**Project:** Waterloo Over Station Development (Central Precinct)

**RE:** Response to Submissions – City of Sydney – Item 34

The purpose of this technical memorandum is to respond to the City of Sydney comments on the SSD DA submission for SSD-10439 (Central Precinct). Specifically, this memo responds to item 34 of the City of Sydney submission (the Flux Consultants peer review).

Figure 1: Updated convergence graph

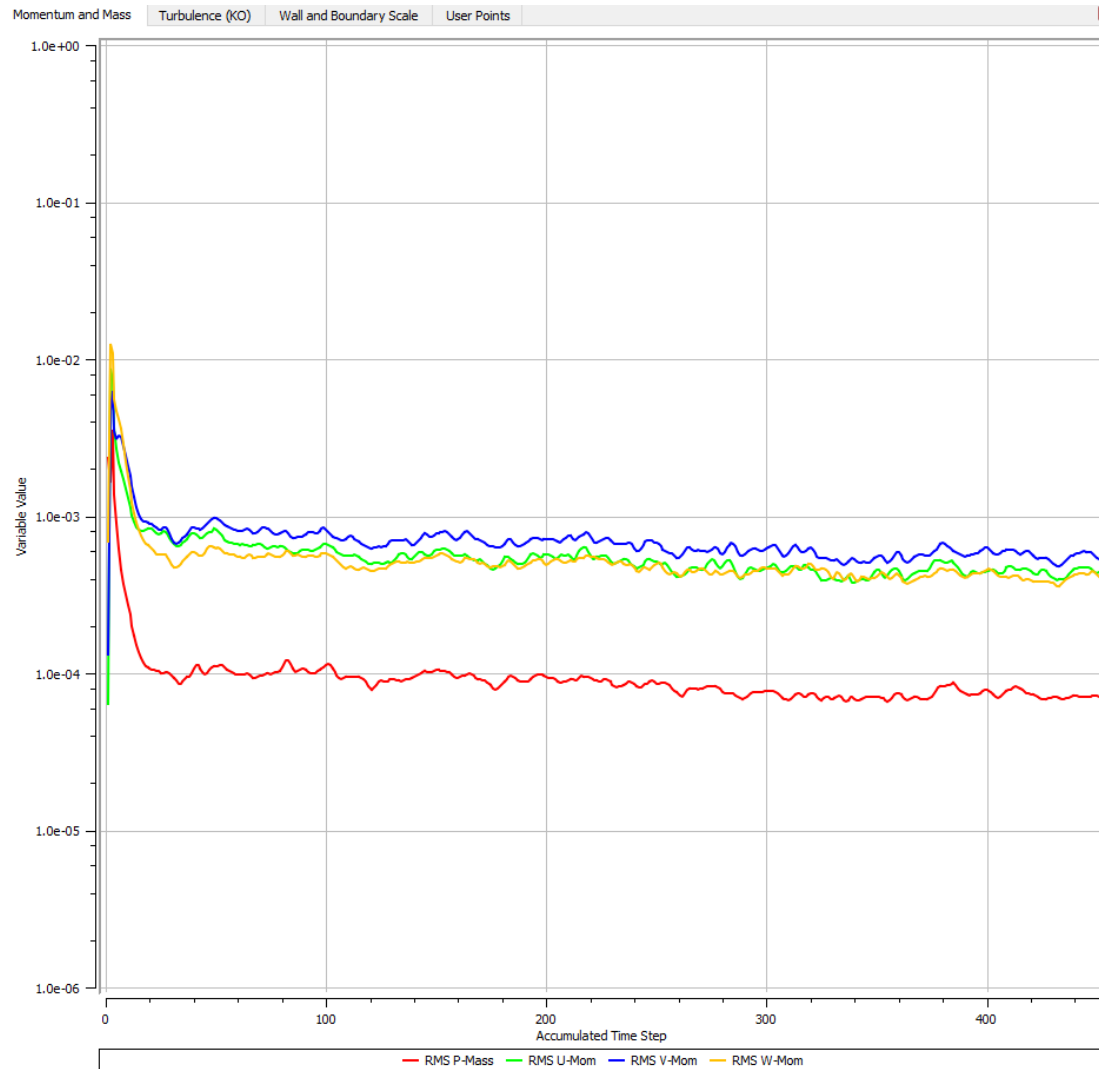
3	A convergence graph is shown for the key variable residual errors. The graph is presented at 300 iterations. It is assumed this is also the timestamp at which the results are taken. The graph shows some initial instability in the calculations, and we recommend additional iterations to confirm that the solution has converged.	Figure 1 within this memo presents the convergence graph with additional iterations requested. Convergence graph provided within the Noise & Vibration Impact Assessment consisted of an extra instability peak because of additional runs that were used to initiate the final run. For the convergence graph provided in Figure 1, we haven't needed to run the model in this manner given it is an update of the original model. The additional iterations confirmed the solution had converged, given the outcome did not change.
4	Results of the CFD calculations are shown for pressures but not airflows or velocity vectors. Airflow plots would add considerable weight and provide confidence to the results.	Velocity contours and velocity vector graphs are presented in Figure 2 and Figure 3 in this document, respectively. The graphs demonstrate the outcome of the modelling has not changed, and provide confidence to the results.

Figure 2: Velocity contour map – acoustic ventilator (in plan)

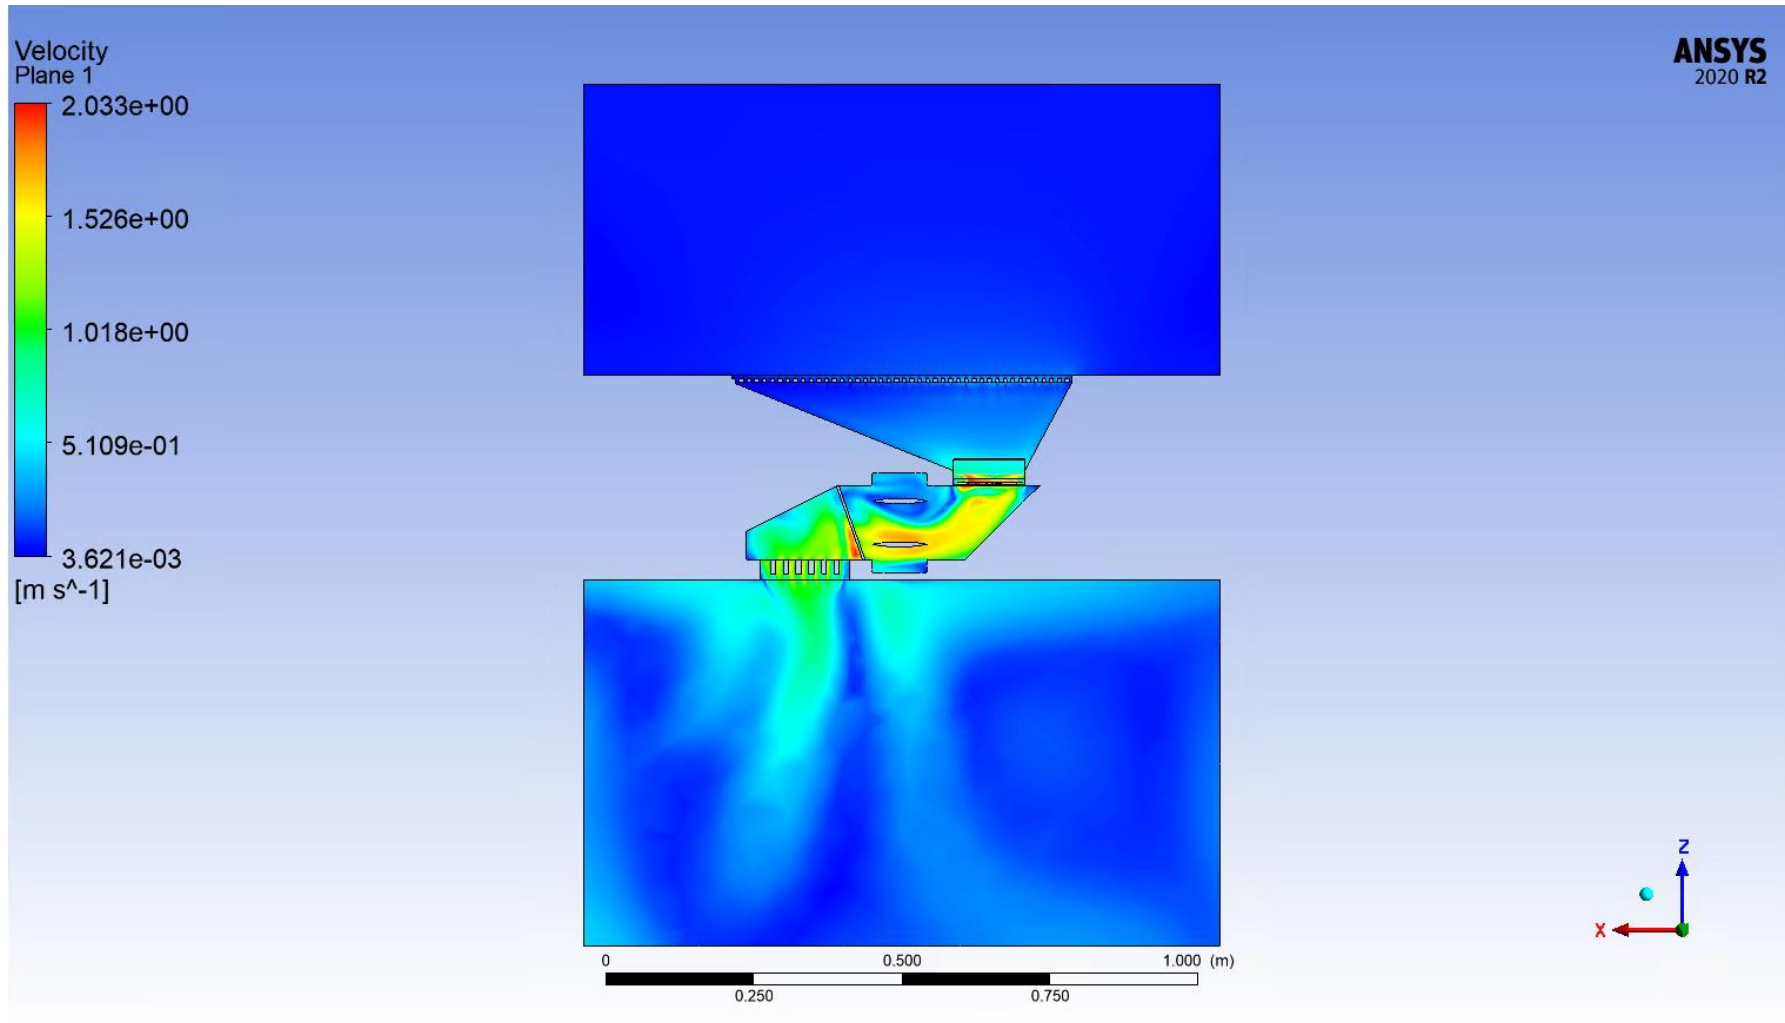
Comment No.	Description	WL Developer Response
1	The report does not verify that non-acoustically treated unobstructed windows opening of sufficient size are provided to meet the balance of the 5% of habitable range served guided by ADG. This is a necessary aspect of an alternative ventilation system and must be demonstrated to comply with the performance pathway.	The WL Developer confirms that non-acoustically treated unobstructed windows opening of sufficient size are provided to meet the balance of the 5% of habitable range served by the ADG.
2	The method of calculating the performance of the flyscreen is not described.	The flyscreen has been modelled as a function of its geometry. It should be noted the diameter of the yarn used in the flyscreen is 0.25mm, and the strands cannot be effectively modelled this thin (feasibly within CFD). Therefore, the strands are modelled with an increased diameter of 10mm diameter, and a spacing between strands to provide an equivalent free area of approximately 60% (this is 8% lower than the quoted geometric free area value quoted in the product specification). In addition to this, it should be noted that either geometry will not produce a significant difference in turbulence because the flow is generally laminar through this element and there are no significant changes in flow direction at this location. This is unlike the louvres, given they impinge the flow.
